Sydney Metro West – EIS Submission

2 May 2022

After reviewing the *Environmental Impact Statement for rail infrastructure, stations, precincts and operations between Westmead and the Sydney CBD*, this submission requests the following amendments to the design:

Diagram – 2 – Depth of Tunnels as per the approved EIS

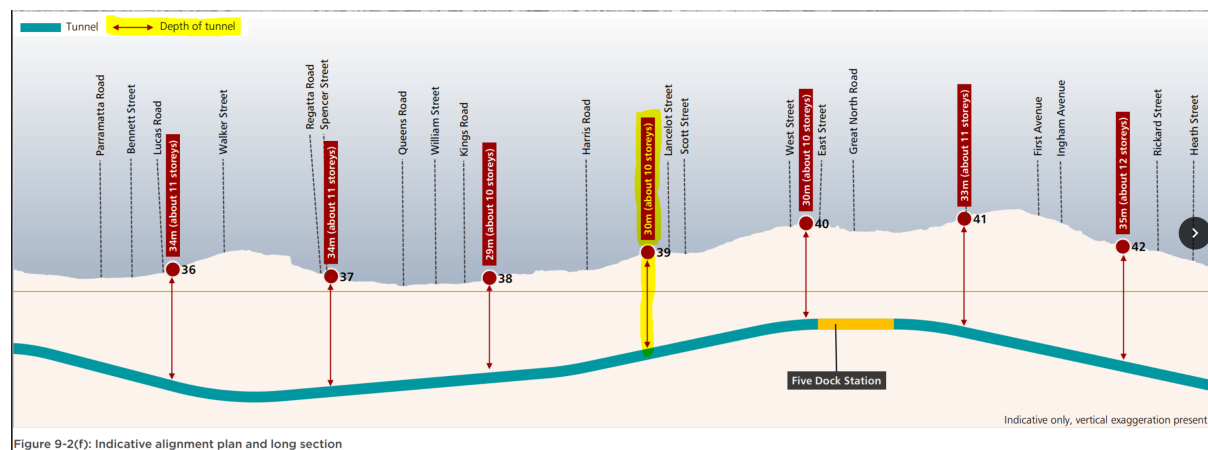
The tunnel depth indicated in the approved EIS is 30 metres from surface to crown of the tunnel (see Figure 9-2(f) from the EIS - **Diagram 2**). However, in late 2021 the interactive Sydney Metro portal website indicated the tunnel depth under the houses of Lancelot Street varied from 23 metres to 17 metres; which is significantly shallower than the approved tunnel depth from the EIS. There was no notification given to residents of the loss of depth in tunnel alignment, and when the residents questioned the change in depth the Sydney Metro team advised that there has been no change to tunnel depth and it is 30 metres where the depth is measured from surface to track level and not to the crown of the tunnel.

Increasing the tunnel depth (to at least what was originally proposed in the EIS i.e 30 metres from surface to crown of tunnel) reduces the impact of noise and vibration on properties as the distance from the tunnels to the properties would be greater. This would also reduce the impact on future value and use of the land as residents would retain full rights over a greater depth of land which would allow more development opportunities in the future as zonings change.

Increasing the Tunnel Depth to a minimum of 30m from the surface to the crown of the tunnels
